Application for Licence Amendment

Licence Number	L8234/2008/2
Licence Holder	Robe River Mining Co. Pty Ltd
ACN	008 694 246
File Number	DER2014/000868-1
Premises	Mesa A Warramboe Iron Ore Mine ML248SA, G08/82, G08/85, G08/90, L08/166, L08/177 and L08/178 FORTESCUE WA 6716
Date of Report	04 January 2024
Decision	Revised licence granted

On 20 October 2023, the Licence Holder submitted an application to the department to amend Licence L8234/2008/2 under section 59B of the *Environmental Protection Act 1986* (EP Act). The amendment is limited only to an update to condition 3, Table 2 of the existing Licence L8234/2008/2 to change the Tailings Storage Facility (TSF) 1 freeboard requirements.

Figure 1: General arrangement of the pond (54.0 mRL), maintaining 0.5m freeboard to the spillway level (54.5 mRL) during normal operations.

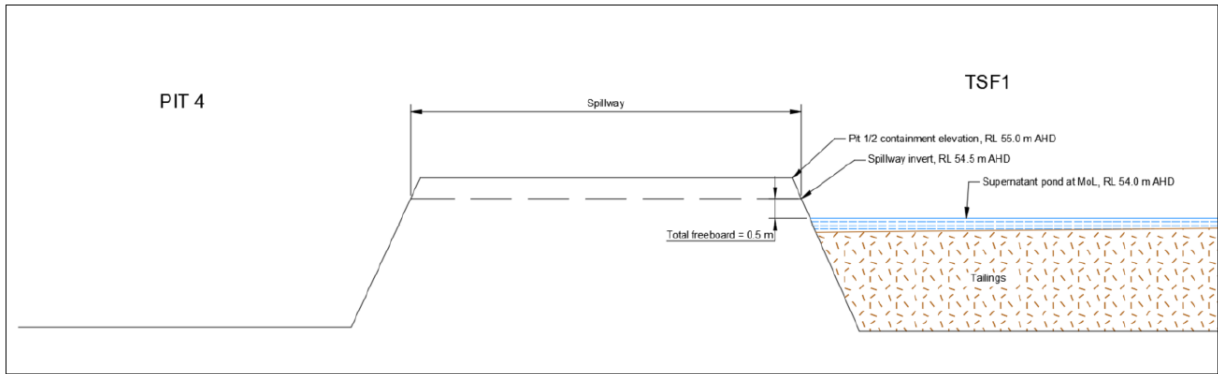
- “Reassessment of the catchment reporting to TSF1 has shown that 1.5 m freeboard between the decant pond level and the spillway level is not adequate to store the 1:100 AEP 72-hour rainfall event above the decant pond without spilling, and cannot be maintained. The License holder requests that 0.5 m freeboard be maintained between decant pond level and the spillway level during normal operations with inflows of excess floodwater, including the 1:100 year 72-hour rainfall event, managed by spillway transfer to Pit 4.”

- “TSF1 will continue to be managed to maintain the required 0.5 m freeboard between decant pond level and the spillway level, Pit 4 will accommodate excess floodwaters resulting from the 1:100 AEP 72-hour rainfall event (and has capacity to store extreme events including the 1:5,000 AEP 72-hour rainfall event). Pit 4 was always intended to accommodate excess floodwaters. Widening of the existing spillway will be required to transfer floodwaters, including those from extreme (1:5,000 AEP 72-hour) rainfall events to Pit 4.”

Refer to Figures 1 and 2 which show how the proposed arrangements will operate.

Condition no.	Proposed amendments
3, Table 2	<p>TSF1 and TSF2 freeboard condition spilt</p> <p>TSF1 freeboard updated – 0.5 m freeboard must be maintained between the operating pond level and the spillway level during normal operations with inflow of excess floodwater managed by spillway transfer to Pit 4</p> <p>TSF2 freeboard condition retained, but with the removal of reference to '54.5 m RL' for the spillway level</p> <p>Figure 11 added to location</p>
Schedule 1	Inclusion of Figure 11

Figure 2: Operation of the spillway during storm events (including the 1:100 year 72-hour rainfall event).

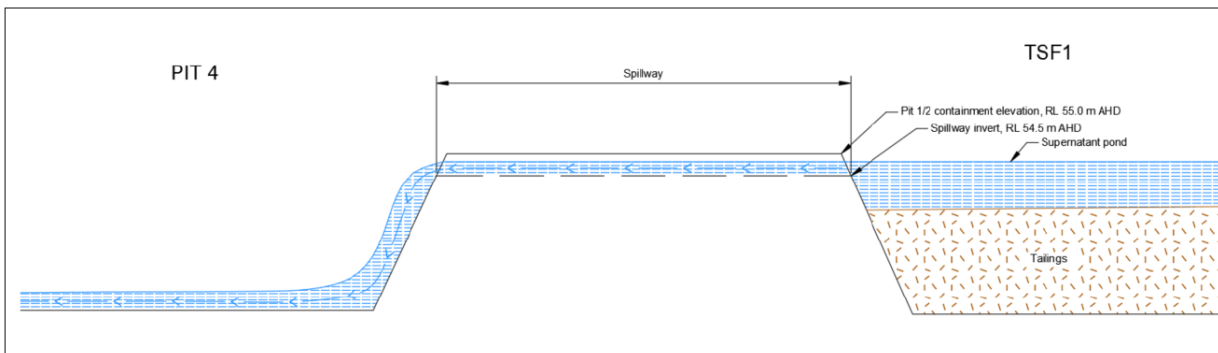
- “DMIRS did not have any objections to the flow of water from in-pit TSF1 via the spillway to Pit 4 during the 1:100 AEP 72-hour rainfall event. The widening of the spillway to meet the 1:5,000 AEP 72-hour event design criteria was also endorsed.”
